BULLETIN # 191-B

### FITTING W41/W55/W56 OR W19 WIREFEEDER TO OLDER MODEL WELDMATIC

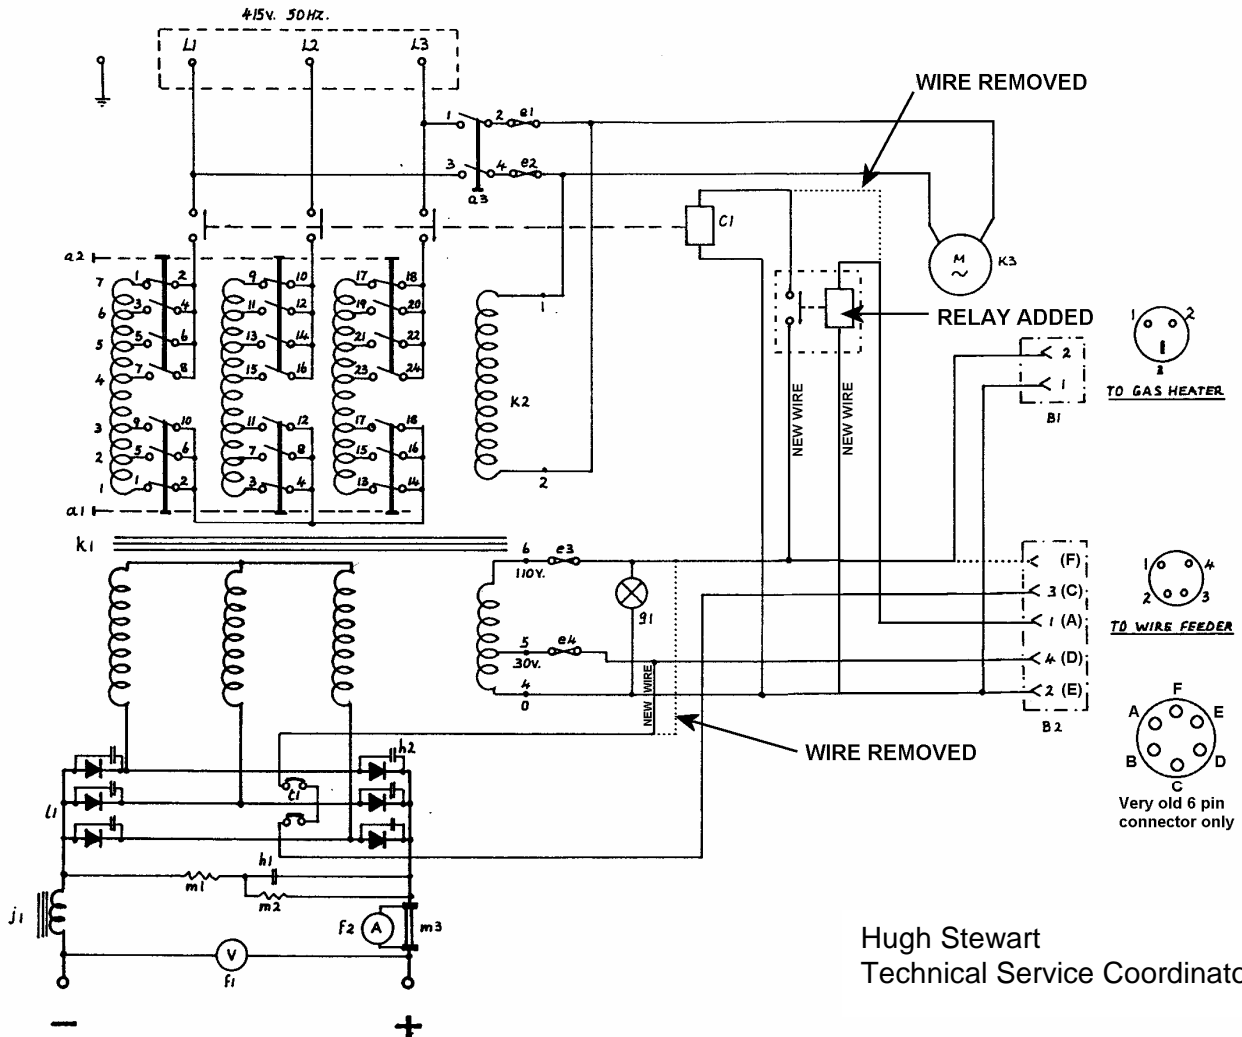
A W41/W55/W56 or W19 wirefeeder is not suitable to be connected directly to an older power source. Older model Weldmatic machines used 110 volt ac to drive the contactor, whereas the newer machines use a 30 volt ac contactor coil. The more recent wirefeeders (W41/W55/W56 & W19) are designed to switch a 30 volt coil rather than the 110 volt contactor coil used in the older machines.

The following circuit shows the correct addition of a relay to allow an older model Fabricator, CP33 (prior to serial number 33104.xx, manufactured May 1993), to be safely connected to a current series wirefeeder. The modification would be similar for other early Weldmatics which used a 110volt contactor coil. The relay contacts switch the 110 volt contactor coil, with the relay coil being switched on by the wirefeeder. The relay would need to have contacts suitable for switching 110volt ac, and using a 30 volt ac coil.

Another solution would be to replace the contactor in the power source with one utilising a 30 volt coil . For an older series Fabricator the contactor used on the current Fabricator, CP38-0/10 would be suitable.
